Warm Springs Extension Art Program

BART Warm Springs Extension Art Program Questions and Answers

**SAN FRANCISCO BAY AREA RAPID TRANSIT DISTRICT
REQUEST FOR QUALIFICATIONS
WARM SPRINGS STATION AND FREMONT STATION ARTWORK**

Figure 1: Glass Pavilion and Concrete Columns

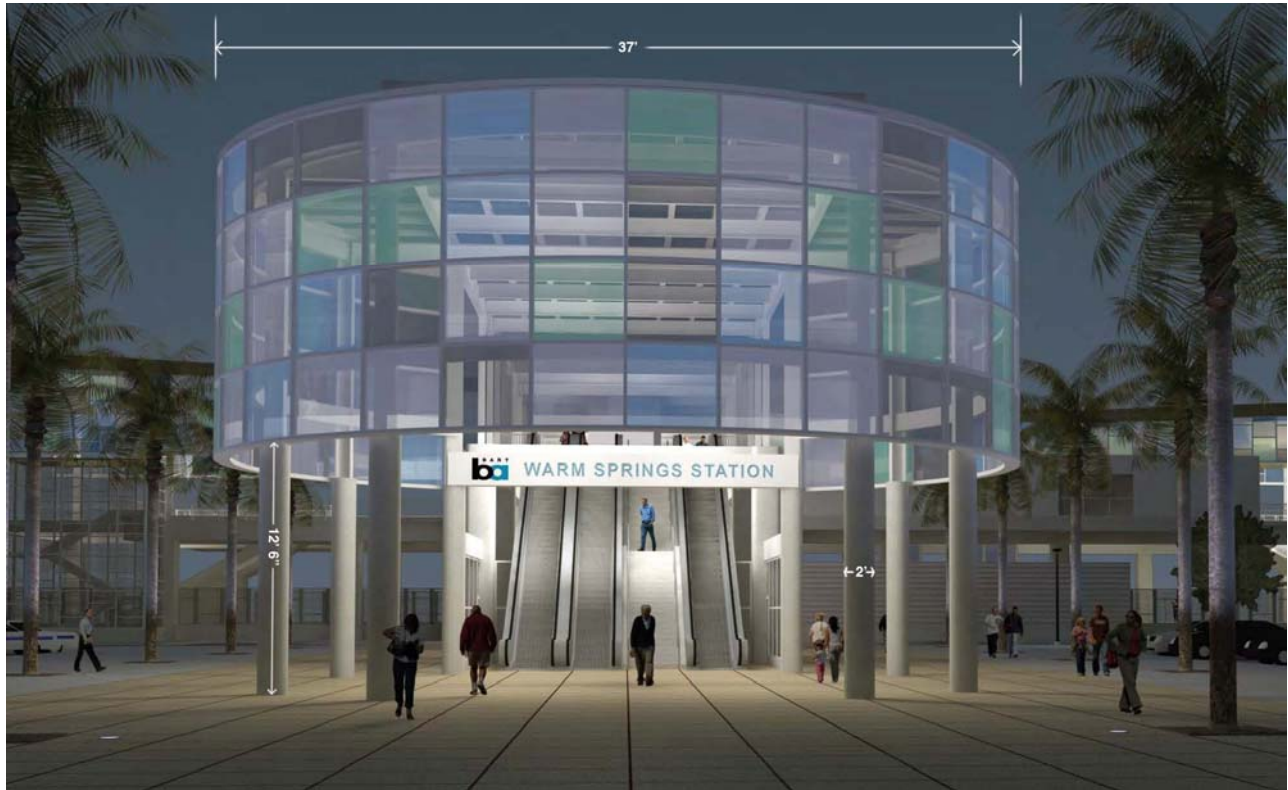
Question: Could you please confirm the total square footage of the plaza level pavilion and concourse curtain wall area(s) identified to be address by an artist for the San Francisco Bay Area Rapid Transit District: Warm Springs Station/Fremont Station 'art glass' public art project?

Question: I am applying for the Entryway Columns at the Warm Springs BART station and I have just been struck by a gross inaccuracy in your planning: The six columns surrounding the entry pavilion are circular and will measure approximately 2'-0" in diameter and 12'-6" in height, or approximately 25 square feet. You forgot pi, which means the surface area to be covered is actually more than three times what you have here. (78.5 per column). I am wondering whether the budget can be readjusted to accommodate this new reality, or whether the number of columns, or the height of the mosaic/art portion can be reduced.

Response: The glass curtain wall at the concourse level measures approximately 6,565 feet at the east elevation and 6,606 at the west elevation. Each glass panel measures approximately 4'-9 1/2" x 4'-9".

Response: We do not have dimensions yet for the pavilion glass but its current diameter is estimated to be 67 feet in diameter (note the change from 37 feet stated in the RFQ). The project is design-build and the drawings are not yet at 100 percent completion, so dimensions on all of the art sites may change.

Response: We have made changes to the column dimensions in the RFQ posted on CAFE. The most recent calculation for the circular columns is closer to 78.5 square feet. We do not have dimensions on the rectangular columns yet. Please note that all dimensions are approximate as this is a design-build project and the final designs are not yet complete. The amount allocated for the column artwork will not be modified.
